CORRIGENDUM - III

Tender Number: IREL/MK/ET/34/2026 dated 17.03.2026

Work Description: Request for Proposal (RFP) for selection of agency for installation of De-Sliming system at HUS (MK Unit) on Engineering Procurement Construction (EPC) Basis

Response for the queries submitted by the prospective bidders

Plan and existing equipment Layout

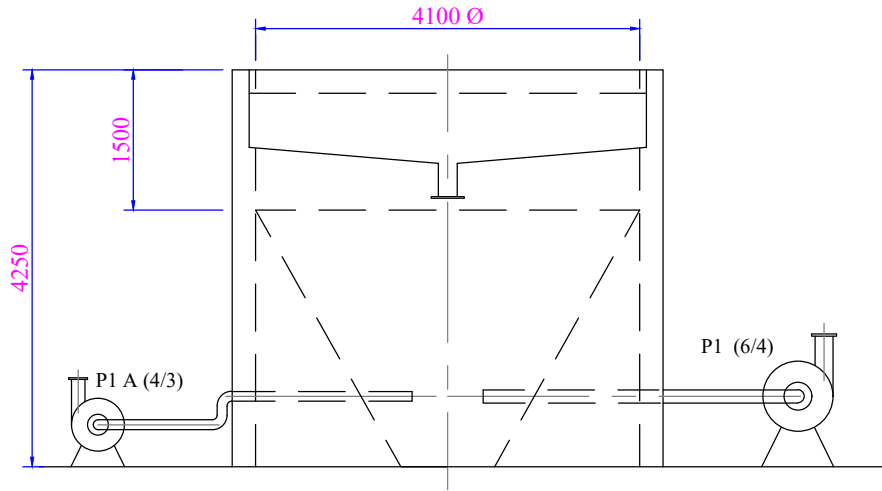
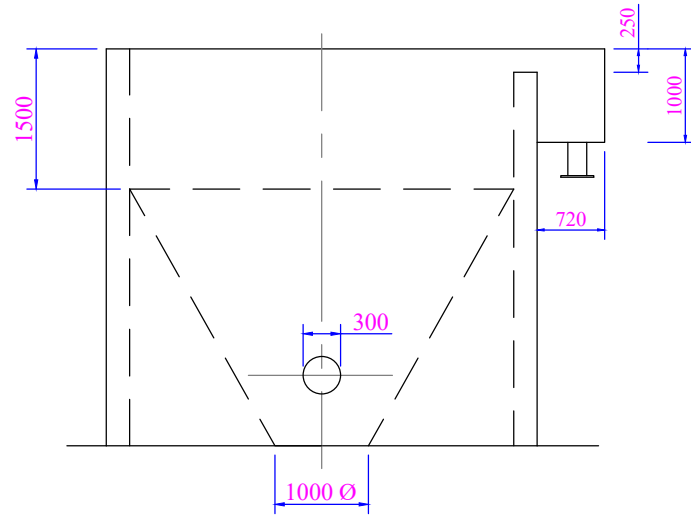
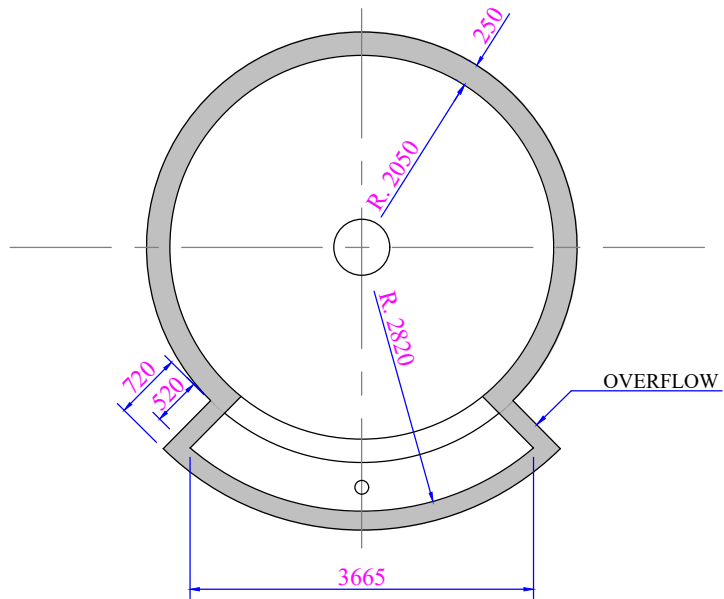
12.	8.e	Supply of all required material including steel, towards installation and commissioning of the screen as per technical specification, with all accessories for satisfactory performance. Design of screen is in the scope of Agency and Agency shall consider mixing chamber outlet chute, dimension of RCC tank (Tank 1) in operation for collection of screen undersize fraction and oversize collection pit.	Based on the site visit, the officials indicated that IREL would share the tank and mixing chamber drawings. Kindly provide the drawings along with all related details.	Existing RCC tank schematic drawings is enclosed as Annexure-I

LAYOUT

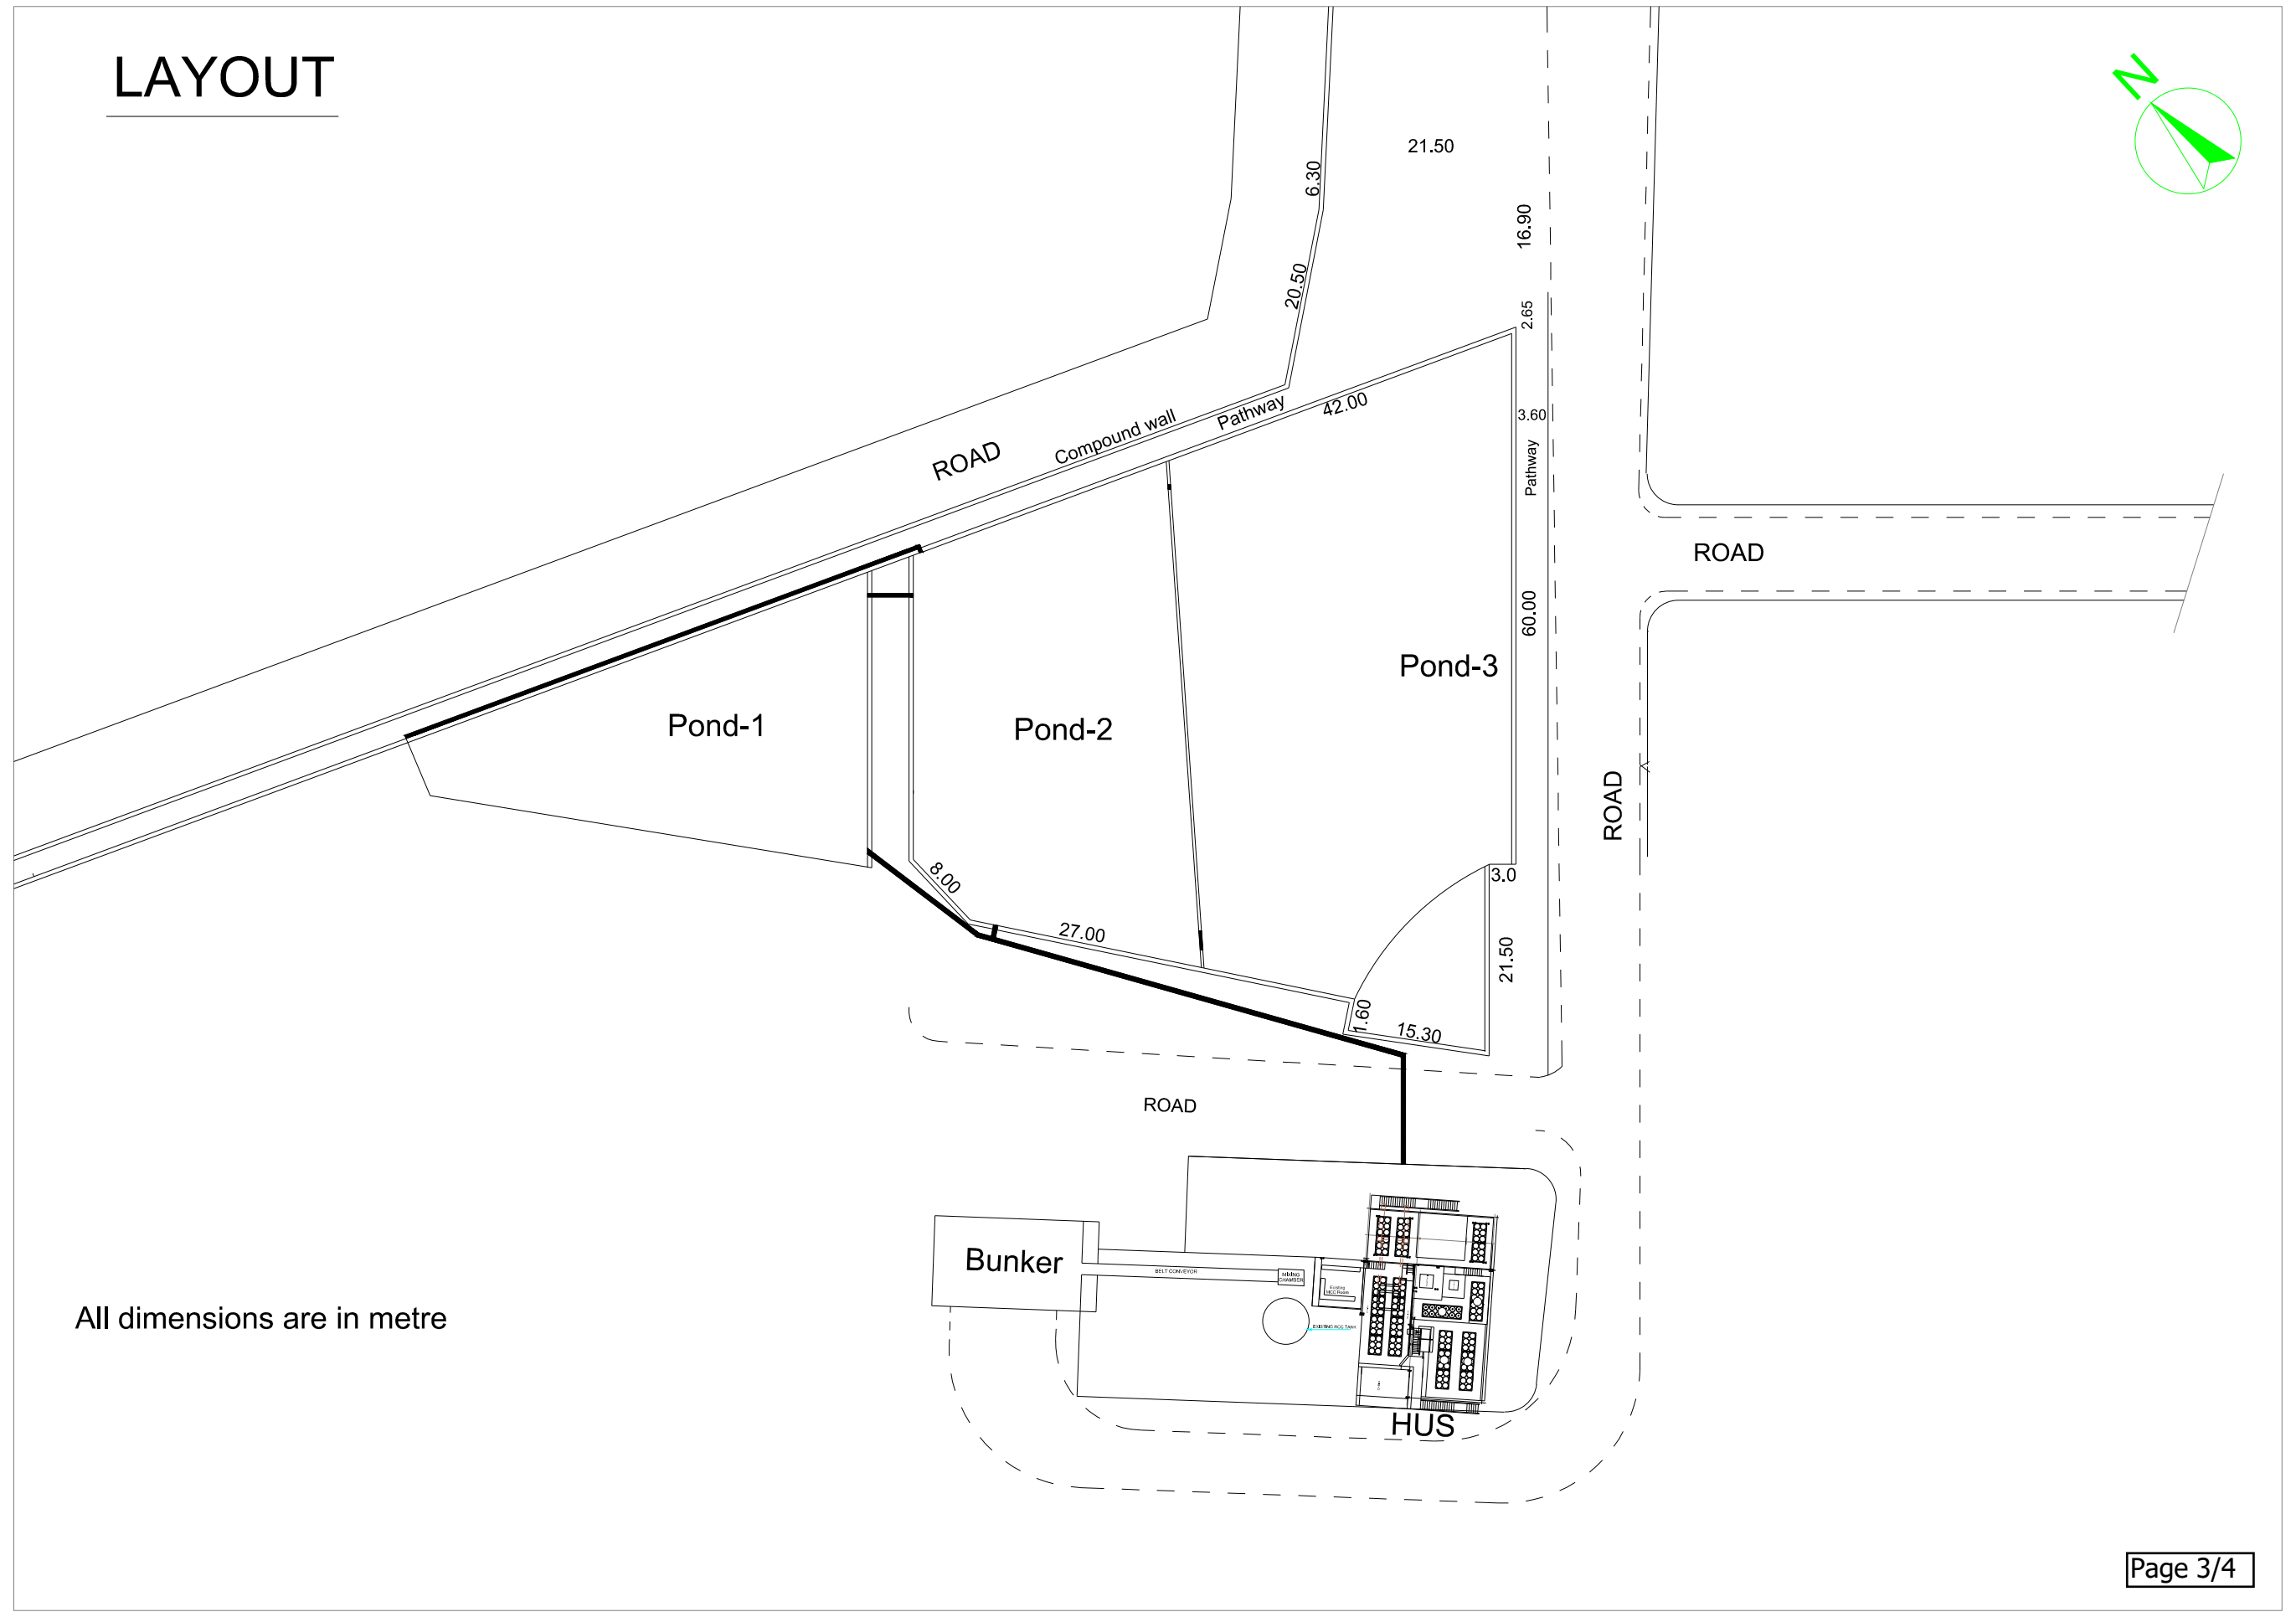
69.		General	Please share proposed Plot Plan, existing Flow Sheet and Plant layout etc for estimation purpose.	Flowsheet, plan and HUS existing layout is enclosed as Annexure-I
